BAKERS HOUSE

25 Bakers Road, Uxbridge, UB81JY

15th November 2019

This Addendum Design Statement describes in detail all the architectural changes made.

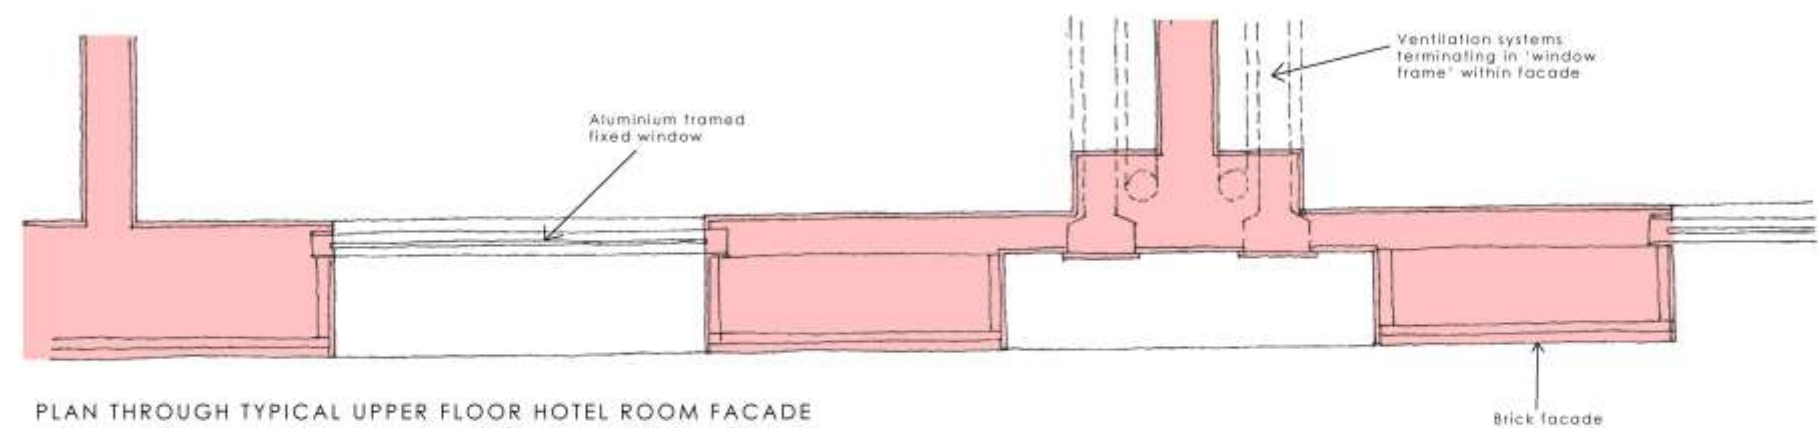
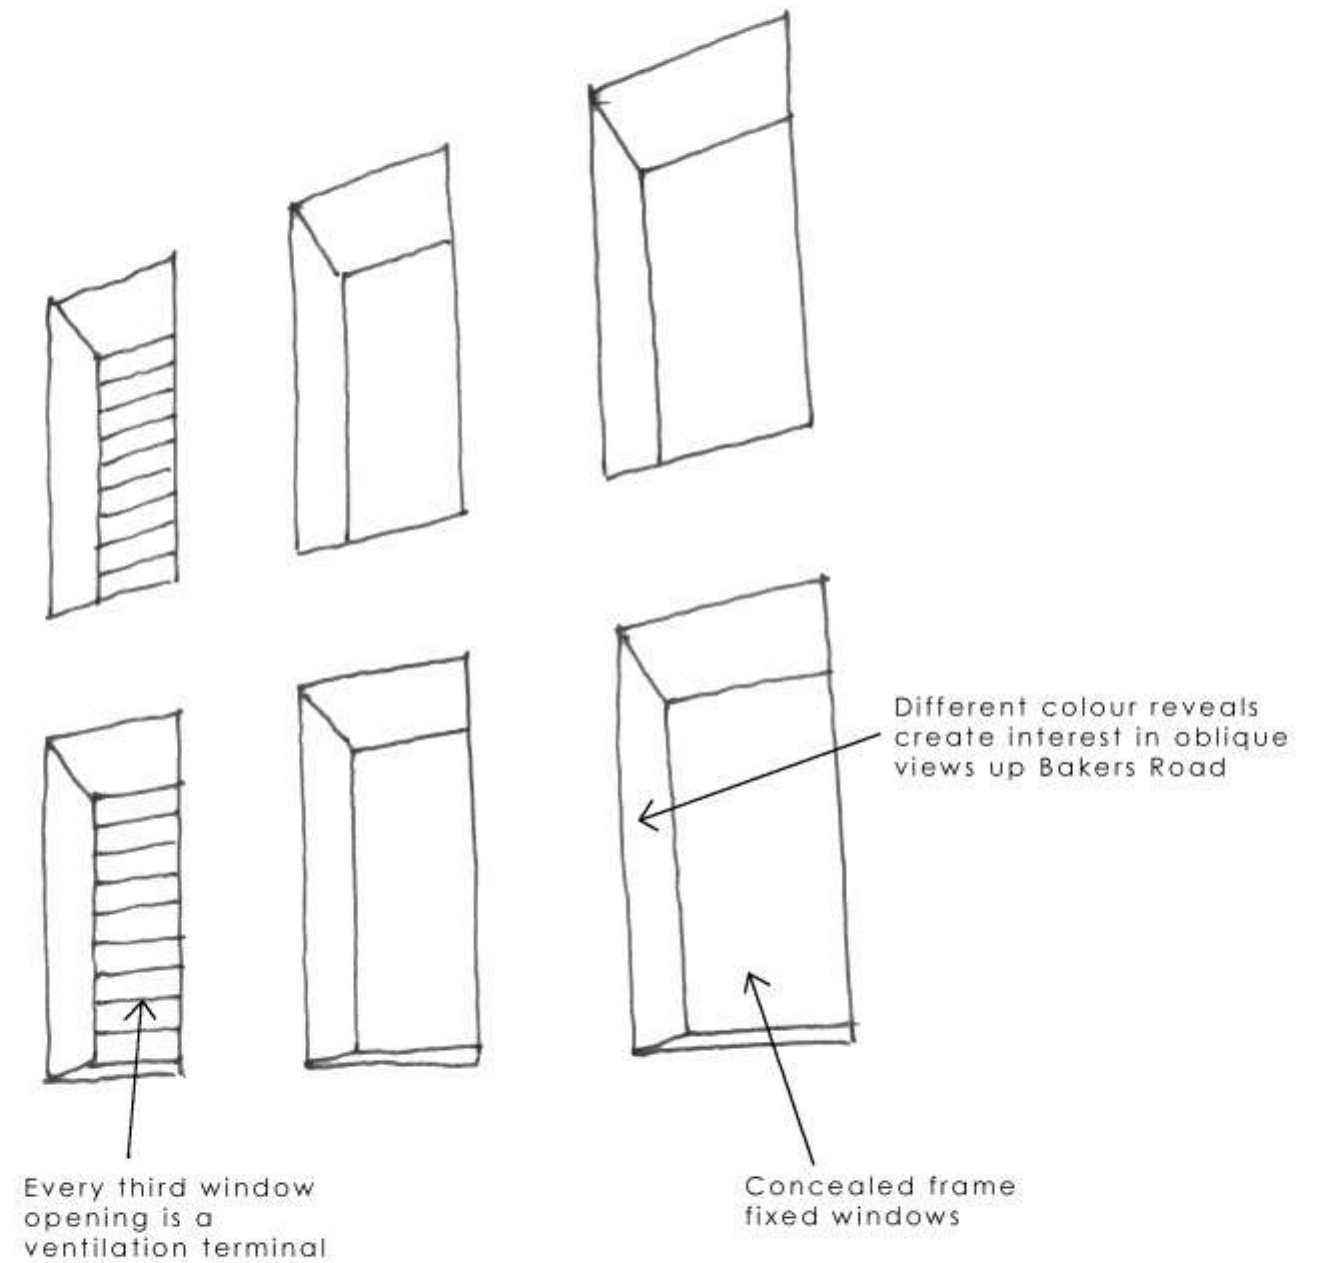
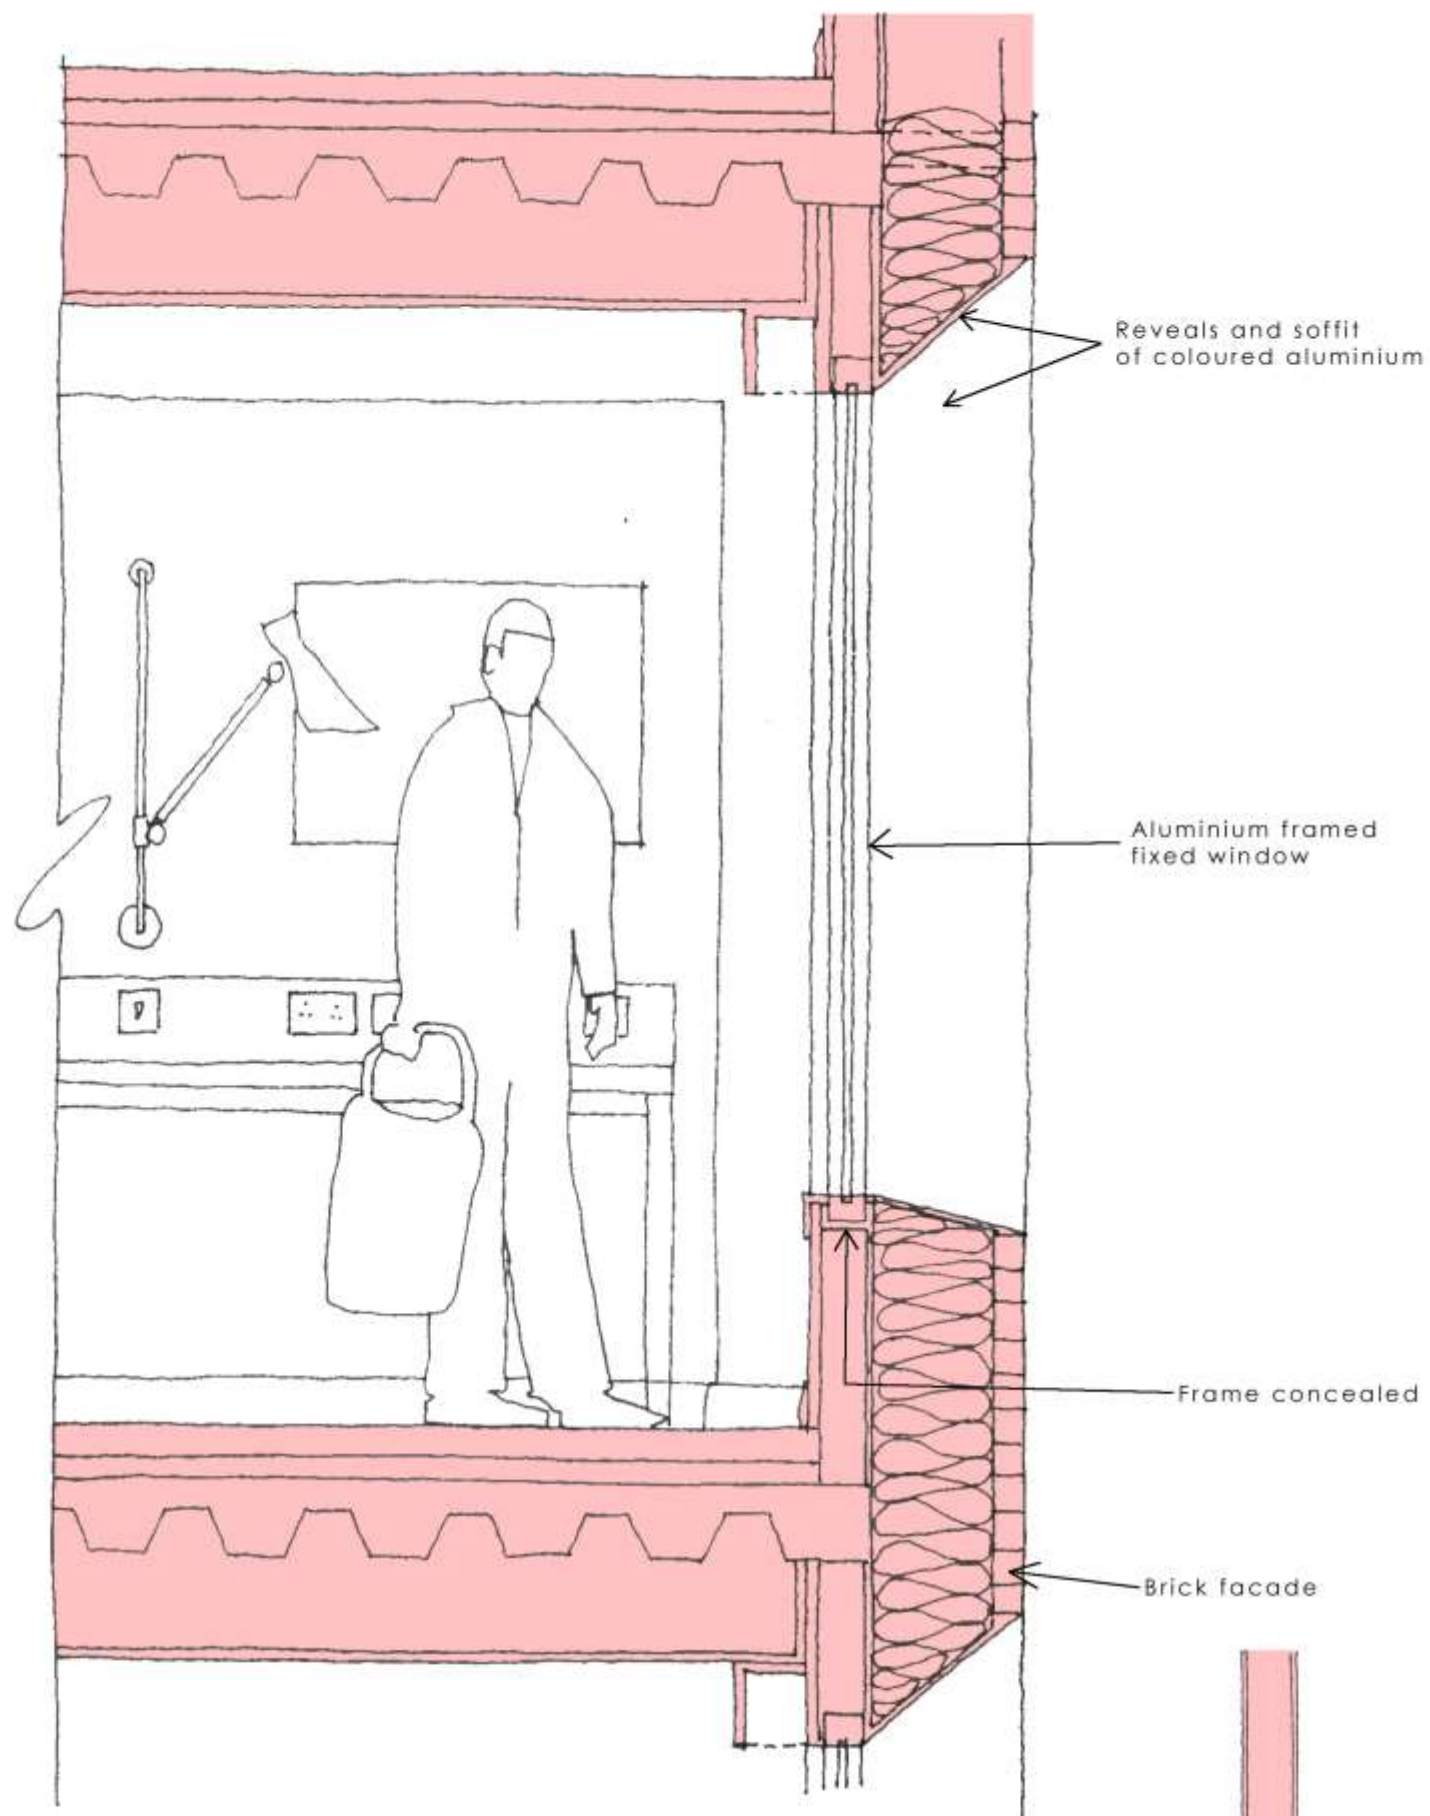
We have now introduced windows on the previously blank north elevation to light the secondary stair. These provide greater interest in views from Belmont Road. If the remainder of the Belmont Road retail block were to be developed (see 'Anticipating Further Development' on page 56 of the original DAS), these new windows would be blanked off. Our clients have retained the right, within their legal agreement with the hotel operator, to impose this.

Similar 'gable' windows have been introduced on the south-east elevation, where they help light the desk area of the new corner room.

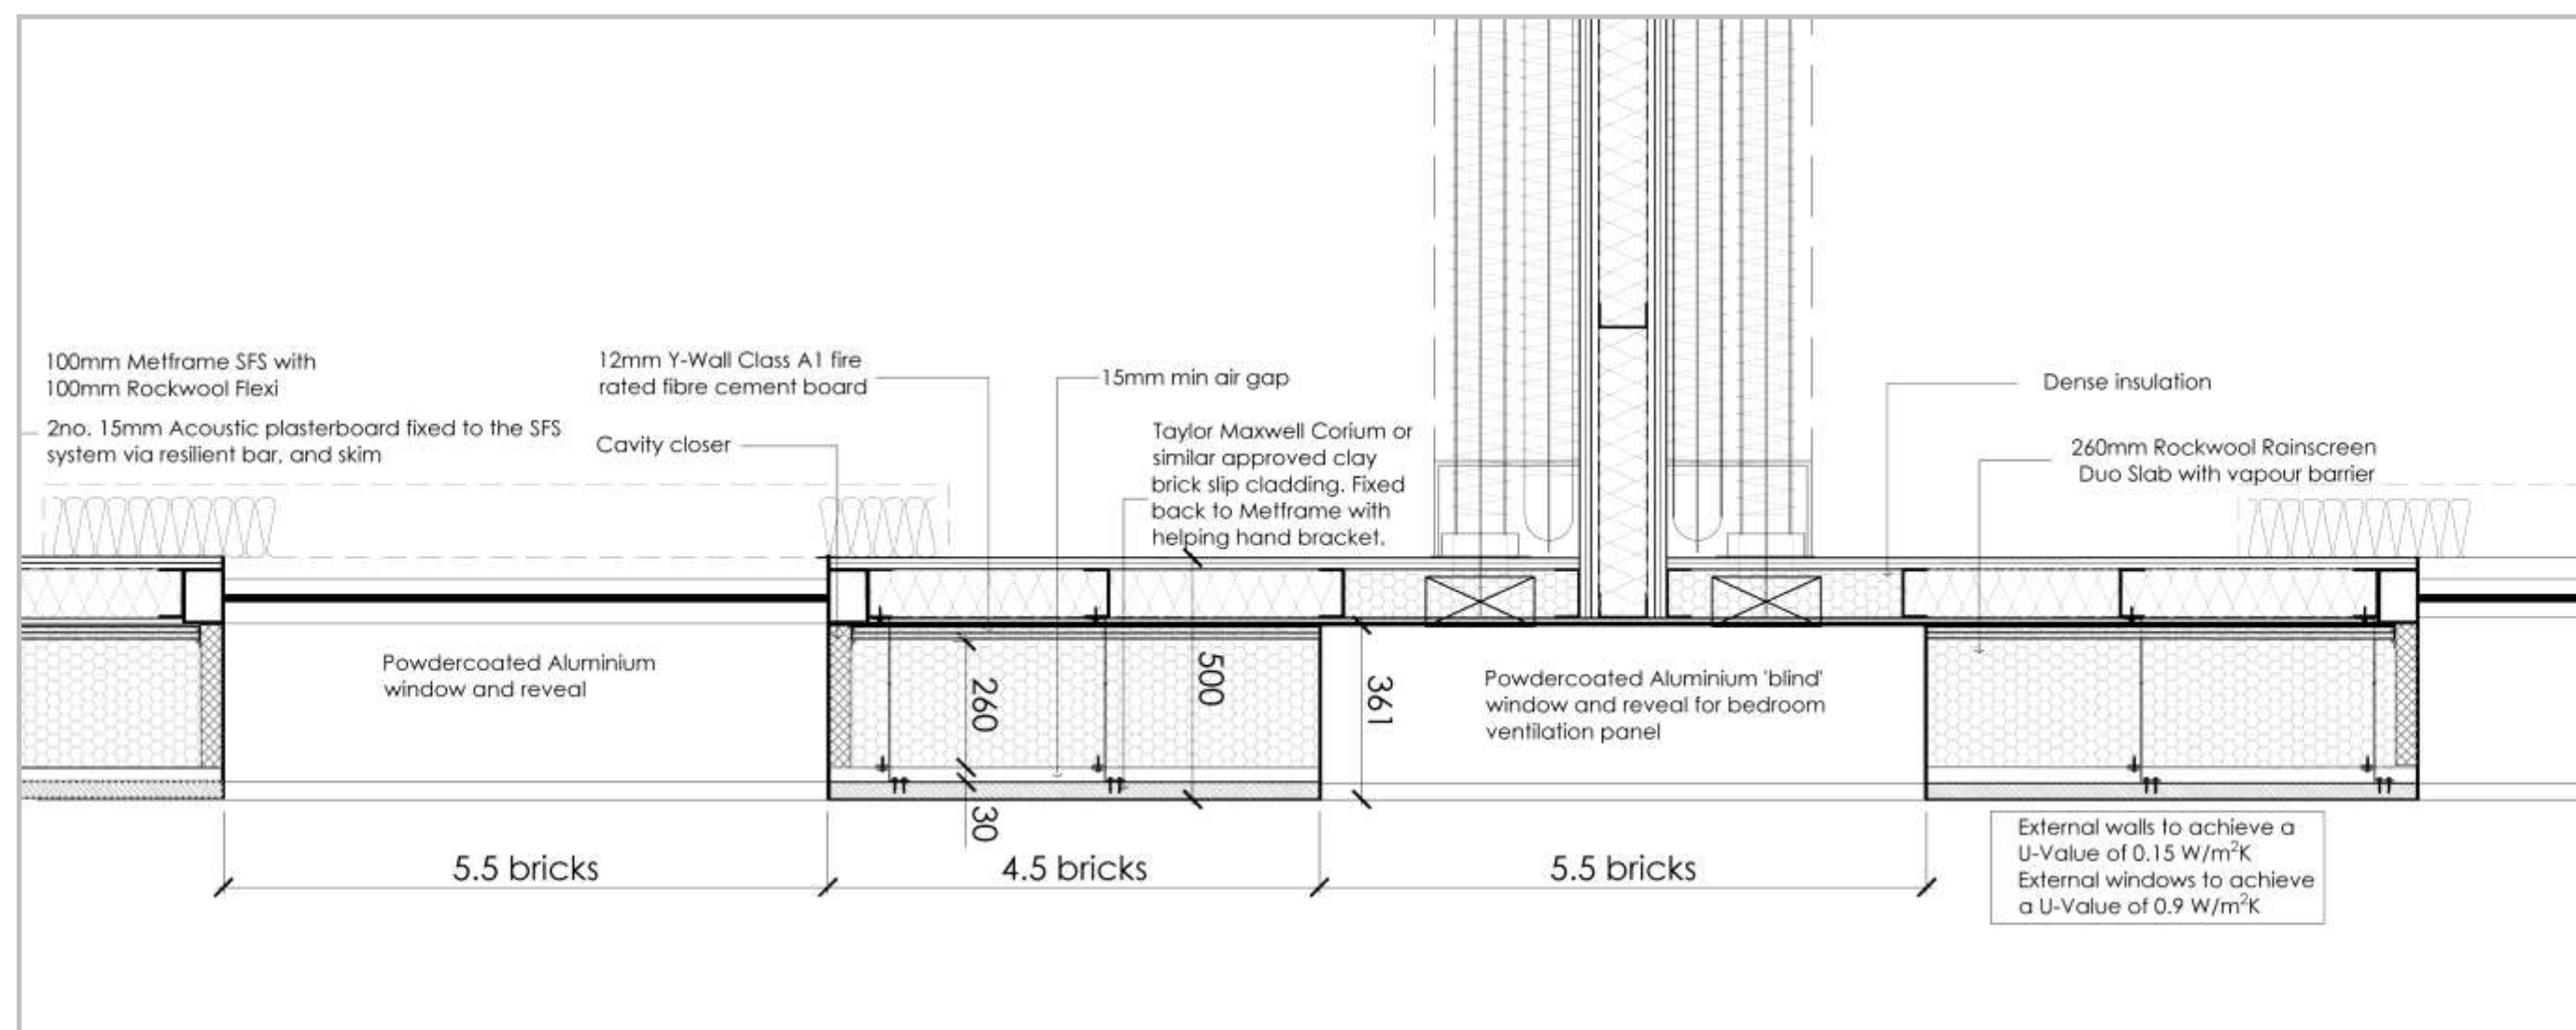
Removing the projecting bay on the front elevation has required us to consider how we treat the resulting elevation. Our proposal is to continue the regular window opening grid that existed for most of the elevation, and to ensure that the revised internal room planning can work within that grid.
